## Re: Major Project MP06\_0130, UTS Ku-ring-gai Campus

This response to the invitation for comment on the State Significant Site Study and Environmental Assessment of the Concept Plan Report (EAR) for the UTS site is, in accordance with the objectives of STEP, weighted towards the environmental aspects of the proposal.

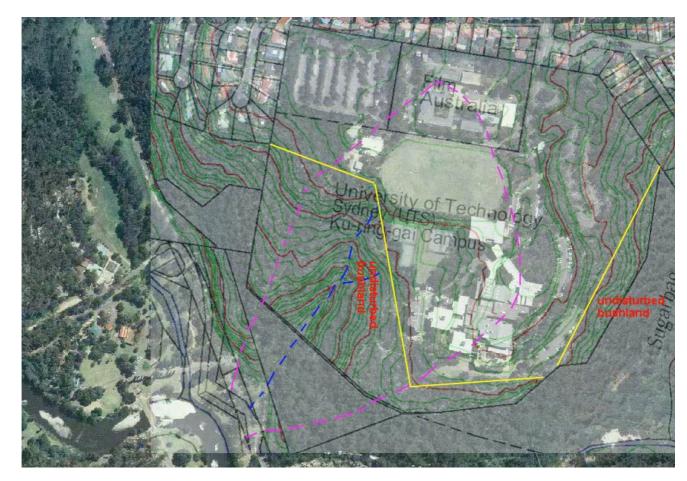
community needs for sports and educational facilities. The proposal as presented needs to be completely reconsidered. Our view is that the public interest is best served by retaining the sports facilities and eliminating most of the bushfire asset protection zones within the high quality western bushland including College Creek. Further expansion of the educational facilities or redevelopment should only be allowed on the car park land to the west of Film Australia and the upper eastern car park areas adjoining the rear of the properties along Kimo St and Abingdon Rd. This would allow consolidation of important bushland reserves with a minimum high bushfire risk interface to housing while providing adequate area for development. The yellow line on the photograph below shows the area of bushland that STEP believes should be conserved.
